Proposal for an update of subclause 6.8 Topology discovery

Josef Dorr, Siemens AG
Günter Steindl, Siemens AG

27 **6.8 Topology discovery and verification**

Figure 1 – Usage example of LLDP

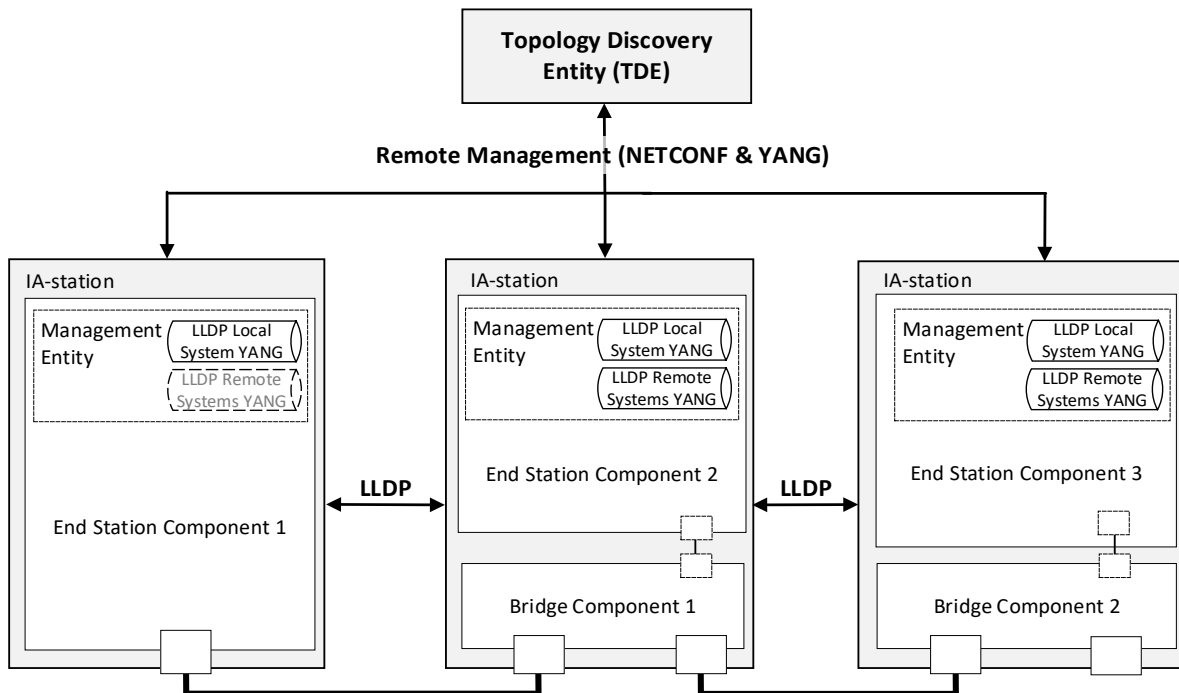
Comments	
#1019	<i>delete EPLAN</i>
#352	<i>delete the sentence beginning on line 3365</i>
#601	<i>delete the text from 3269 to 3272</i>
#602	<i>explain engineered topology</i>
#115	<i>at least one IPv4 management address</i>
#116	<i>save the last received data to the remote systems YANG</i>
#106	<i>remove SNMP/MIB from Figure and text</i>
...	
Contributions	
[1]	<i>60802-Dorr-LLDP-0322-v01.pdf</i>

- Corrected Figure 1 – Usage example of LLDP: -> see Figure 1
 - All IA-stations include an end station component.
- Added subclause 6.8.2.3.4 [Time To Live TLV](#): -> see 6.8.2.3.4
 - Describe all selected TLVs.
- Changed uniqueness of Chassis-ID and Port-ID -> see 6.8.2.3.2, 6.8.2.3.3

54 Figure 1 illustrates an exemplary network showing the LLDP agent implementations in an IA-
55 station consisting of a single end station component and [two IA-stations](#) with end station and
56 Bridge components (see 4.3). The LLDP protocol is used to convey neighborhood information
57 among peers, and [NETCONF](#) is used between the TDE and the IA-stations to query this
58 neighborhood information from the IA-stations. This information allows the TDE to discover IA-
59 stations and the physical network topology.
